Royal Farms #356

DSP-19043

REQUEST	STAFF RECOMMENDATION
Construction of a 4,649-square-foot food and beverage store and a gas station.	APPROVAL with conditions

SUBJECT: Detailed Site Plan DSP-19043
Royal Farms #356

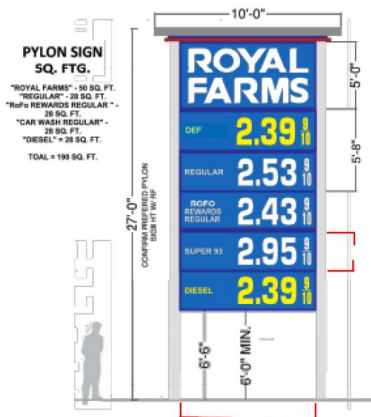
4. Please show the proposed poly sign setback dimension on the site plan
5. Show length dimension of diesel fuel canopy on plan.
6. If the 3 proposed fuel tanks are underground, label them as "PROP. UNDERGROUND FUEL TANK". If tanks are above ground, label accordingly and show the setback dimensions for them.
7. Provide drive isle dimension between loading space and diesel fuel canopy on plan
8. Reference DSDS-704 in the proposed sign height of the Pylon Sign Table, as exempld below:

PYLON SIGN TABLE	
1. LINEAR FEET ALONG PENNSY DRIVE	424 L.F.
LINEAR FEET ALONG ARDWICK PLACE	457 L.F.
LINEAR FEET ALONG ARDMORE-ARDWICK ROAD	257 L.F.
TOTAL LINEAR FEET OF STREET FRONTAGE	1138 L.F.
2. TOTAL ALLOWABLE SIGN AREA (1 SF / 4')	285 S.F.
3. PROPOSED PYLON SIGN AREA	162 S.F.
"ROYAL FARMS" SIGN	50 S.F.
PRICE SIGN (28 S.F. X 4)	112 S.F.
4. MAX ALLOWABLE SIGN HEIGHT	25'
5. PROPOSED SIGN HEIGHT (PER DSDS-704)	27'

DSP-19043 Royal Farms #356

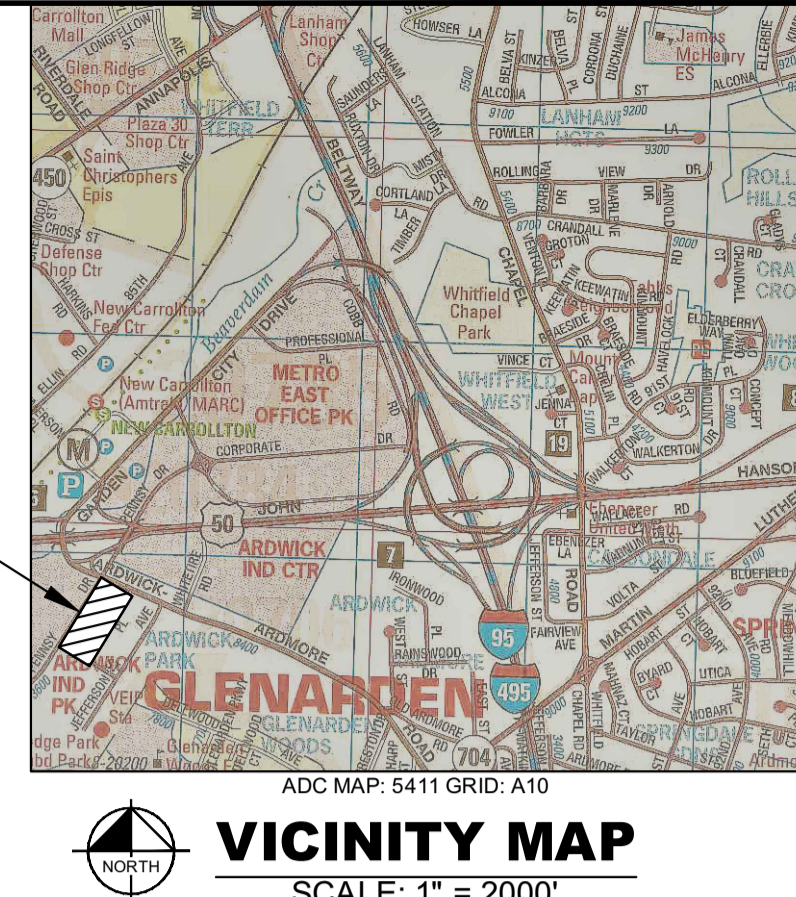
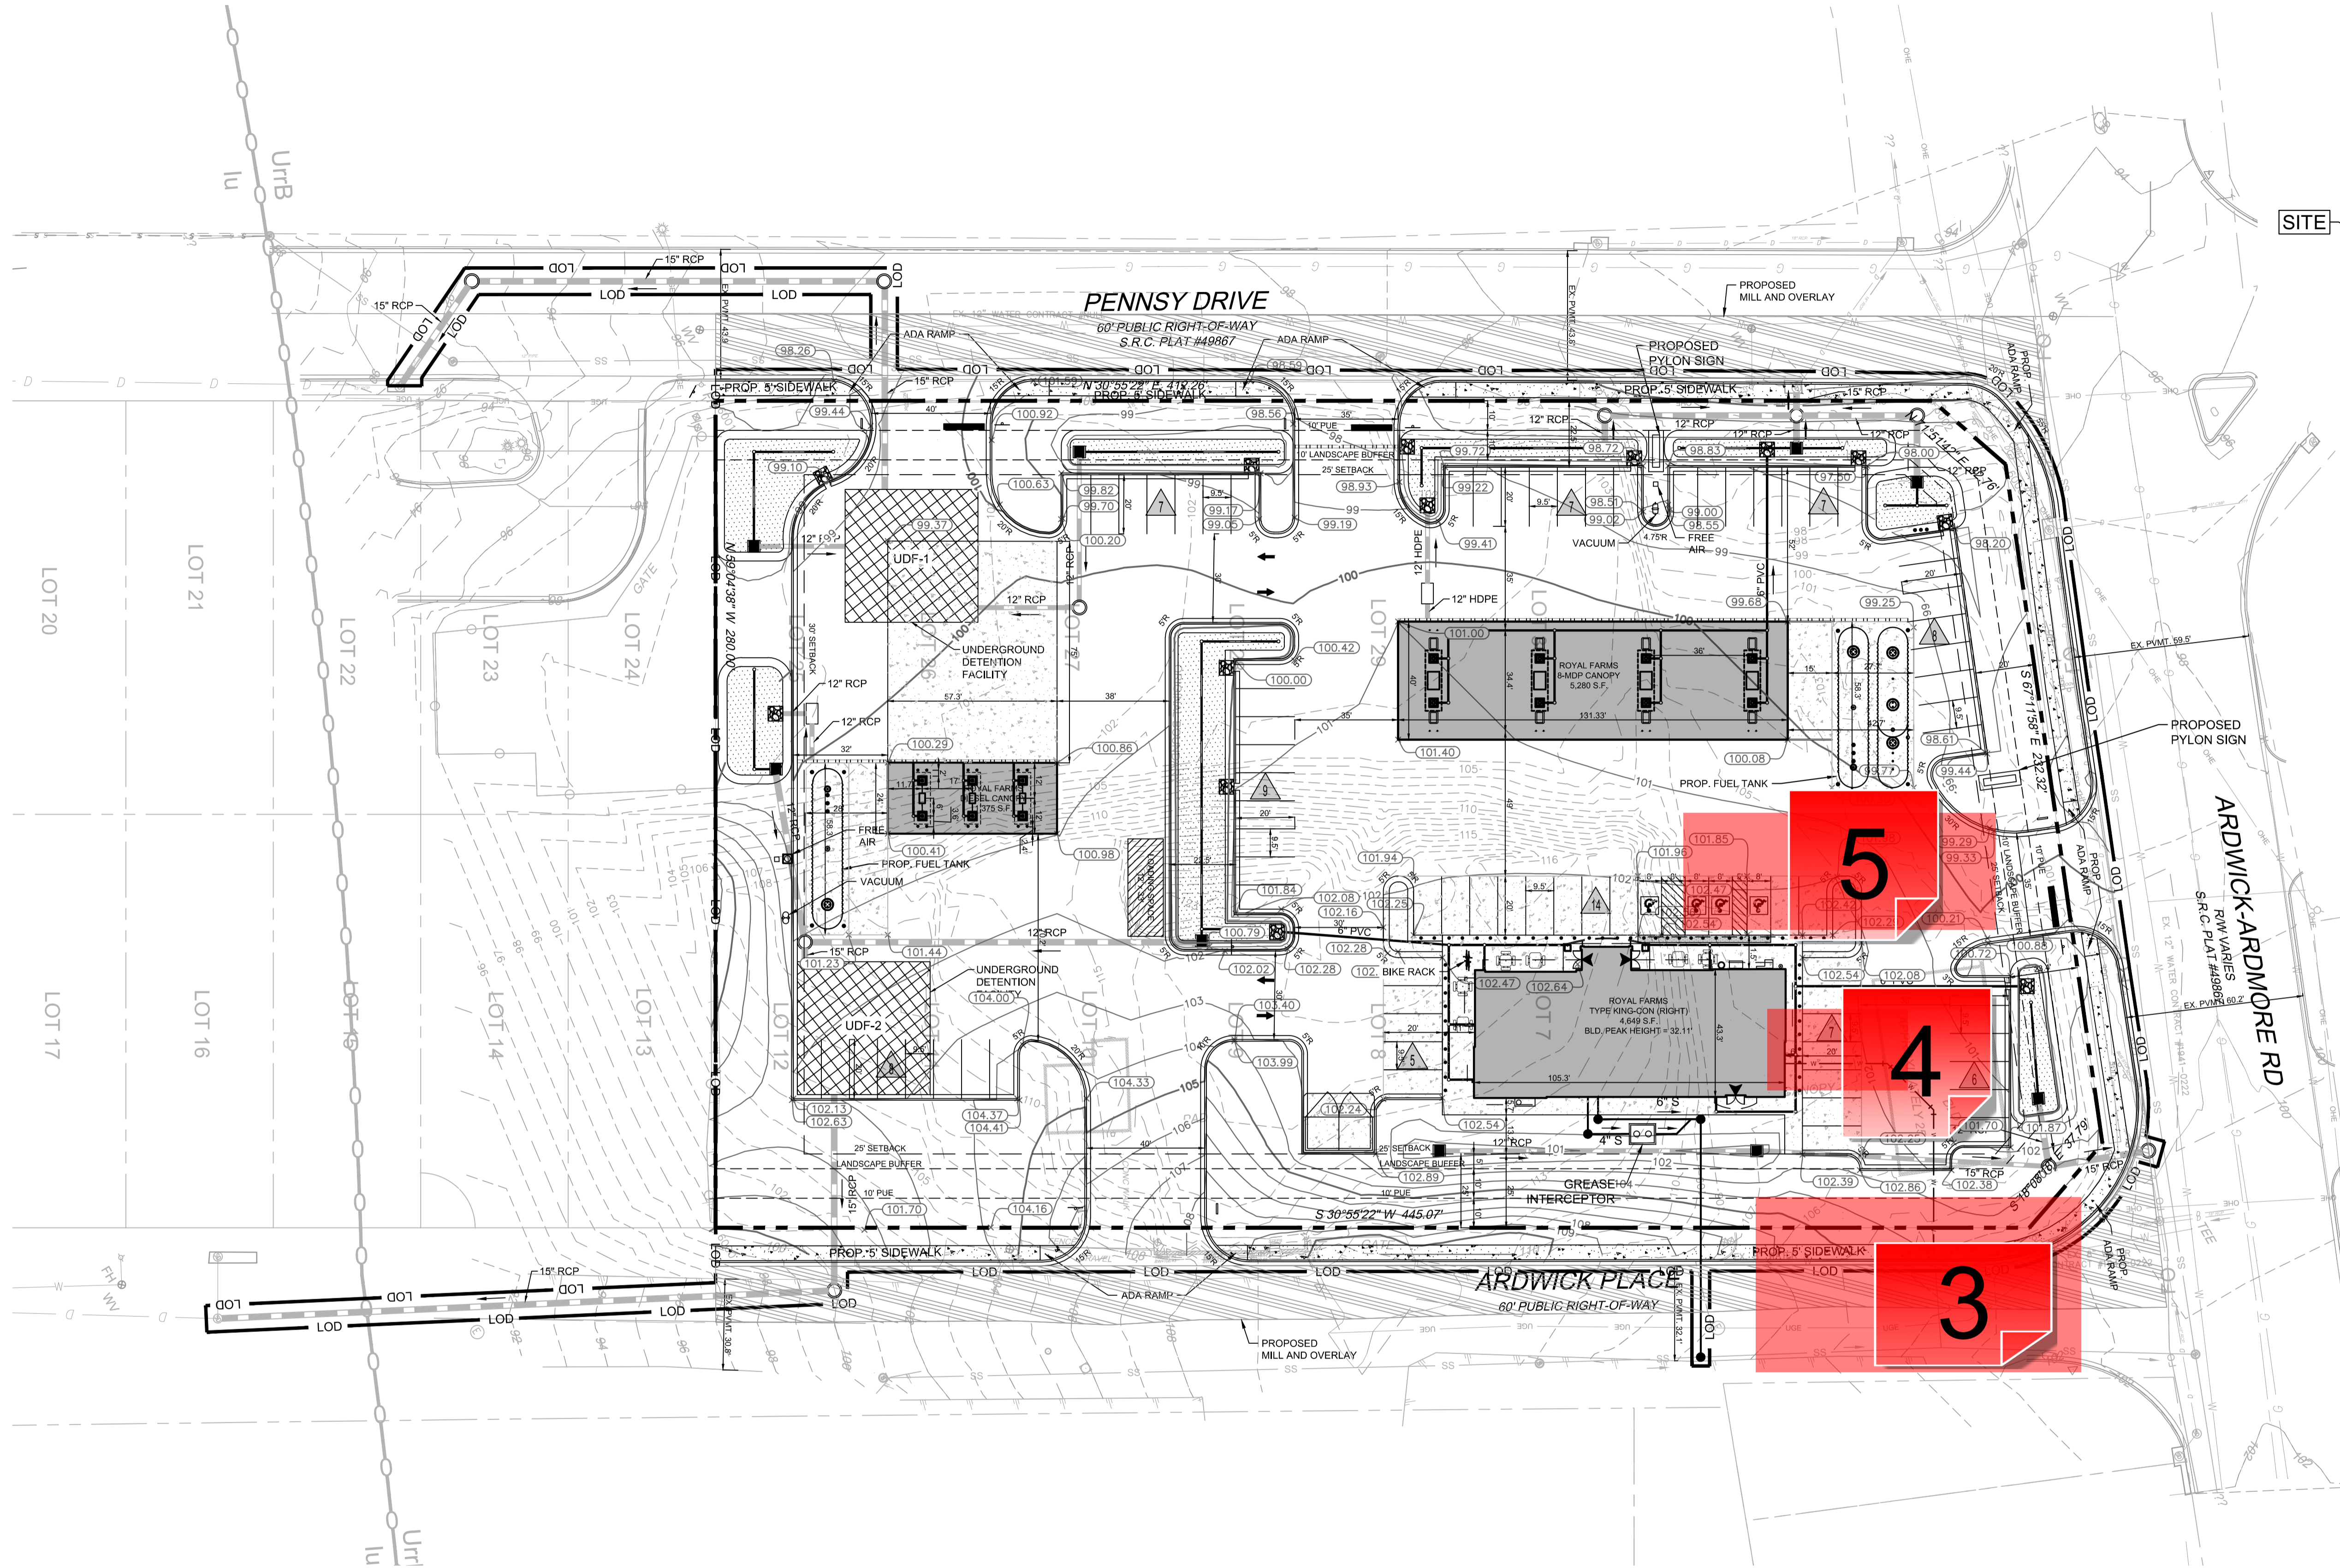
Upon review of these site plans, I only saw one proposed light near the parking spots in between the diesel canopy area and the passenger vehicle gas pumps.

This is an example of the Natural Surveillance aspect of CPTED (Crime Prevention Through Environmental Design).
